From: Rich Prouse [mailto:richp@olsonengr.com]  
 Sent: Friday, October 27, 2017 11:37 AM  
 To: Curleigh (Jim) Carothers <jcarothers@cityofcamas.us>  
 Cc: Kurt Stonex <kurt@olsonengr.com>; Peter Tuck <peter@olsonengr.com>  
 Subject: RE: Dawson Ridge McIntosh Rd. Frontage

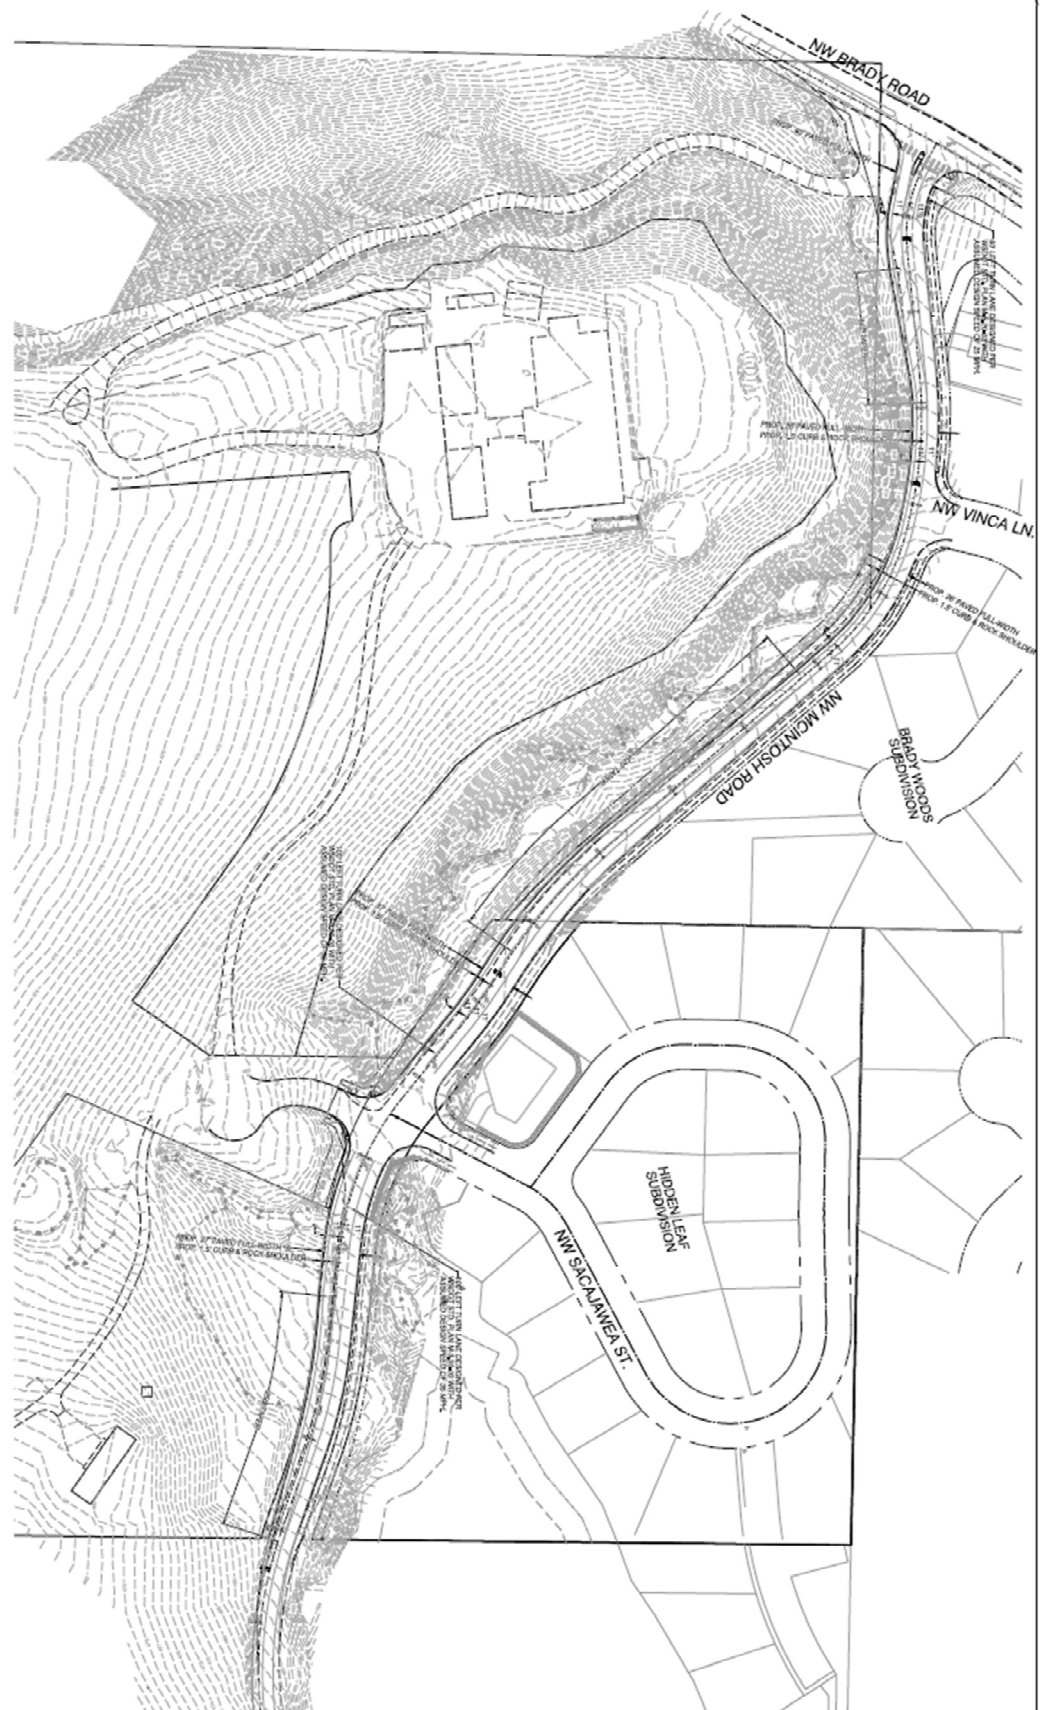
Attached is the McIntosh Rd. layout with requested pedestrian refuge at existing crosswalk location. Please note that this island will obviously have a significant impact on left turn movements for large vehicles. We ran turn movements for a WB50 truck and 45' bus and neither was close to being able to make it with the island, particularly the left turn from Brady onto McIntosh.
